How to modify the fasteners on your Anti-Crusher (A-E)

Bodyguard
Anti-Crusher
(after modifications)

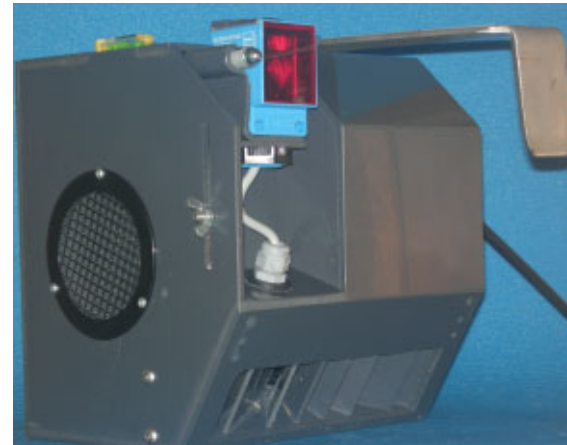
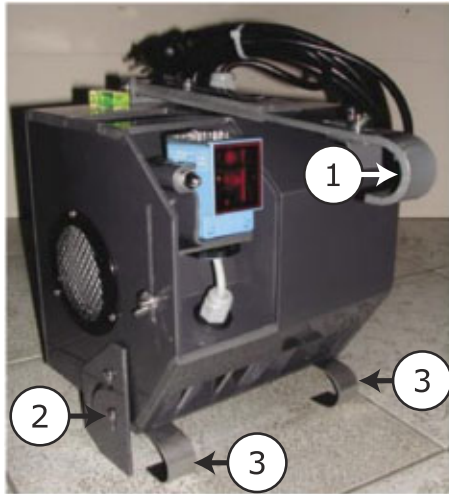
Remove the parts which are not necessary any more.

- Telescopic arm (1)
- Swiveling locks (2)
- Basic hooks (3)

Put back the screws in the holes.

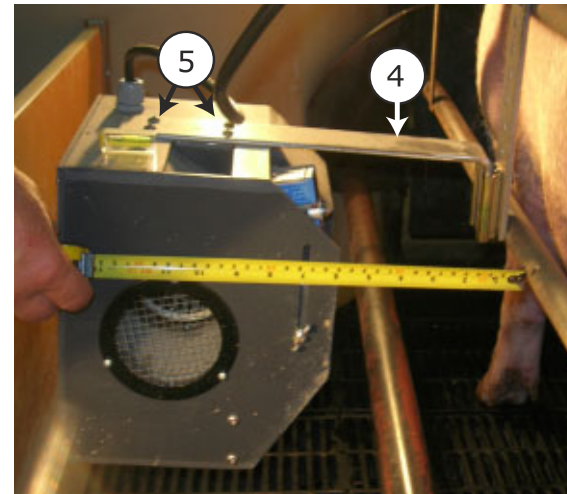
The new male "L-Bar" (4) part must be fixed above the Anti-Crusher.

You will have 4 holes to drill (5) to fix the "L-Bar".

Place the "L-Bar" on the top right in the center of the Anti-Crusher. Press the "L-Bar" on the block of fastener of the telescopic arm which you have just removed (5" of the front of the apparatus).

Mark the exact place of the holes to be made with a felt-tip pen. Open the back cover and visualize where you will drill. Use a bit of 1/4" and 4 bolts of 1/4x20x3/4" to screw the "L-Bar".

The "L-Bar" of 3/16" thickness, made of stainless steel, is folded and cut especially for the Anti-Crusher. It is also made to be fixed in the female fastener placed on the cage.
